**REPORT TO THE LAND USE AND FACILITIES PLANNING COMMITTEE**

**PROJECT:**  
UF-373, FLMNH - Special Collections Building

**PROJECT:**  
UF-200 and UF-200A, University Public Safety Building, and Centrex Building Renovation

**SCHEMATIC DESIGN SUBMITTAL**  
***PARKING AND TRANSPORTATION COMMITTEE***

# proposed site plan

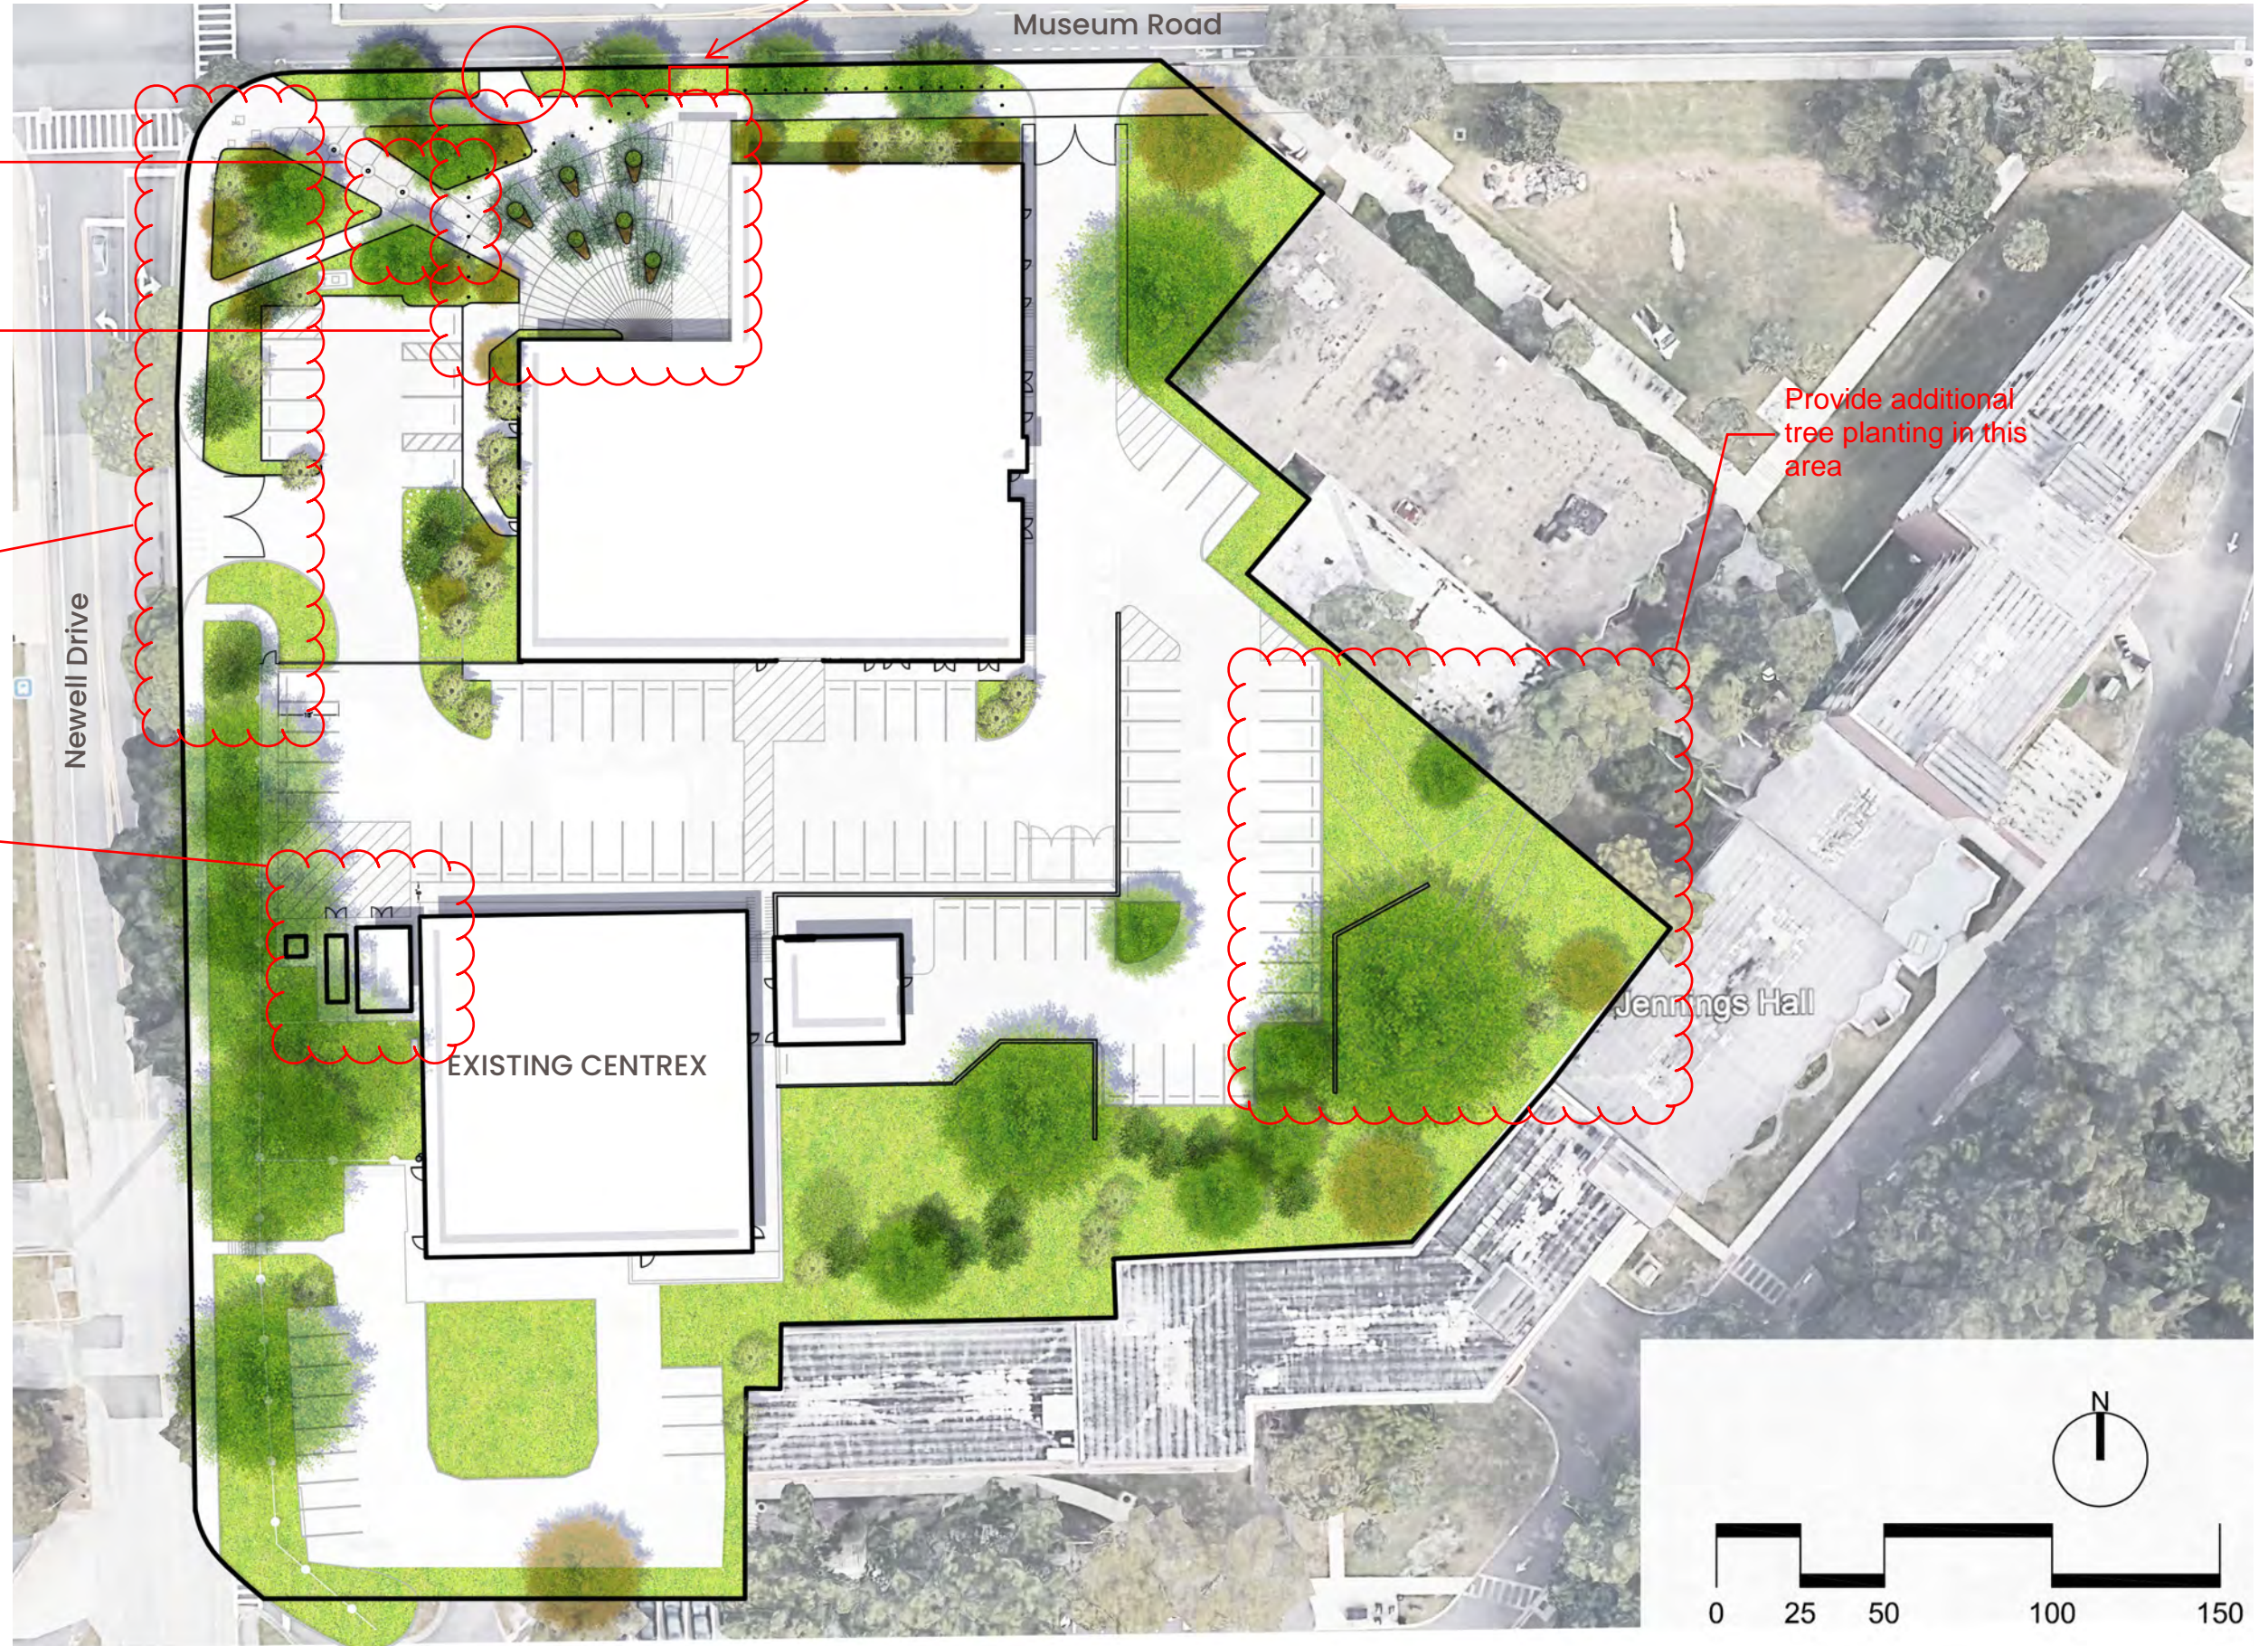
Per Linda Dixon - consider revision to allow for improved circulation at intersection of movement

Hardscape and seating shall comply with or provide justification for deviation from Landscape Master Plan

Erik commented that Newell may want to have a more simple and formal planting

Provide additional tree planting in this area

# existing tree plan

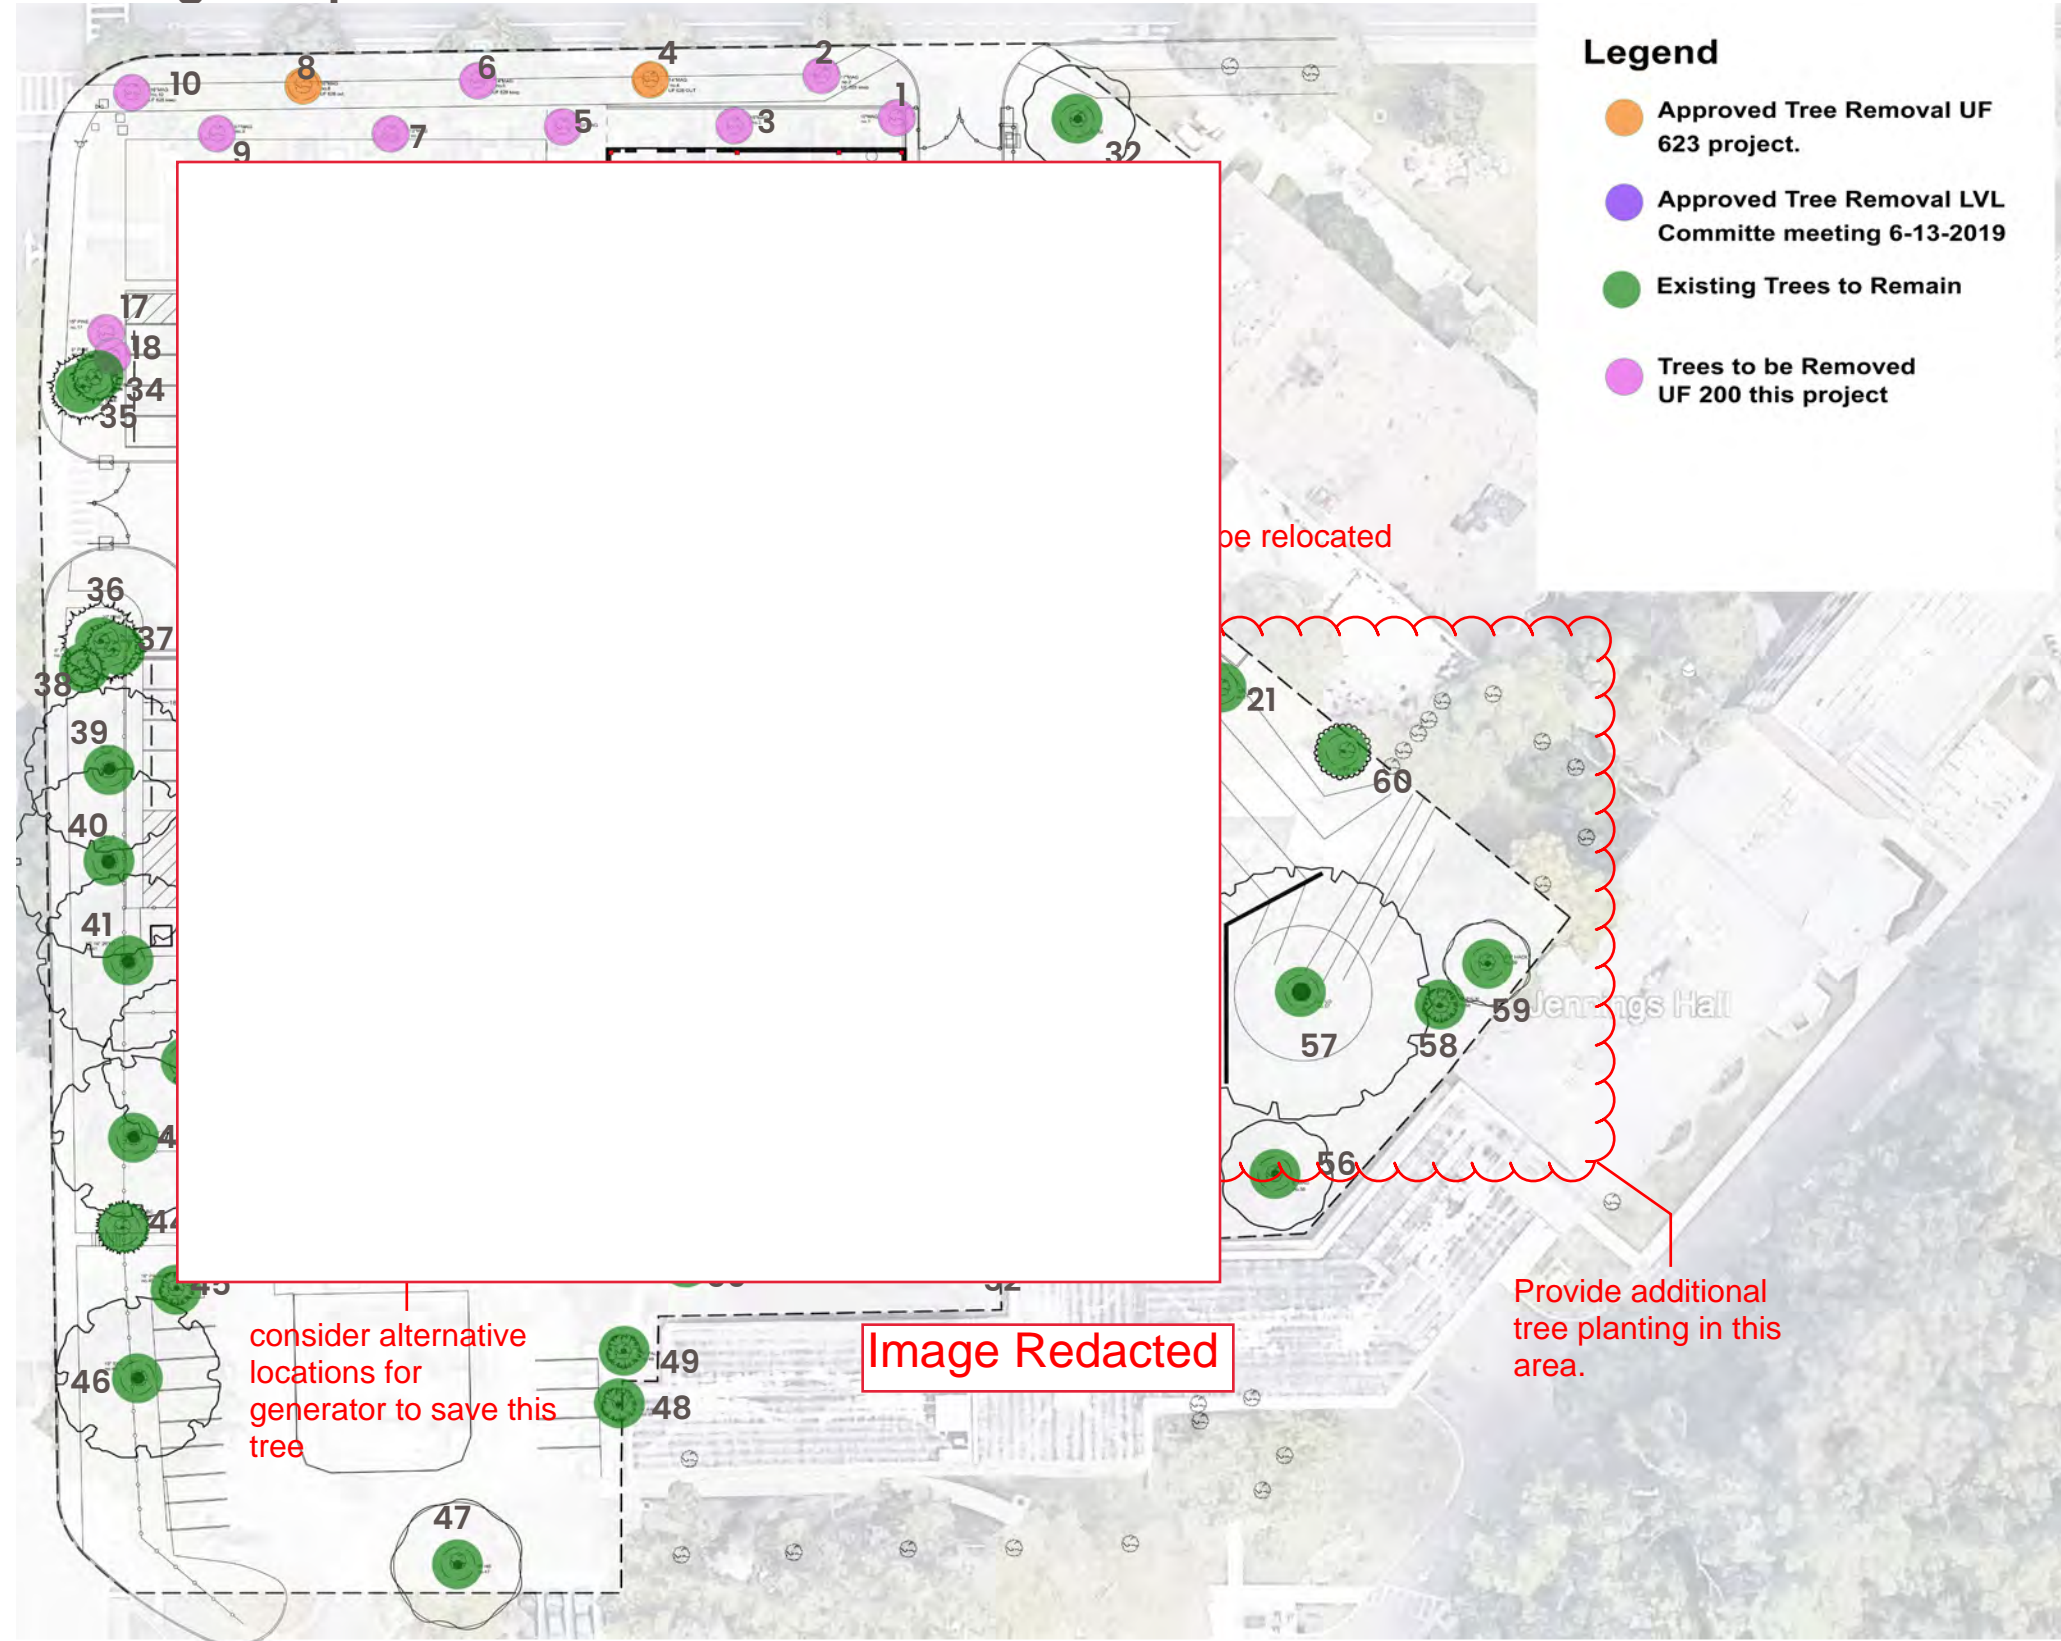
2. Provide additional understory trees at southeast corner of the site to take advantage of the open area.
3. Consider an alternate emergency generator location, if possible, to save the Live Oak tree No. 27.
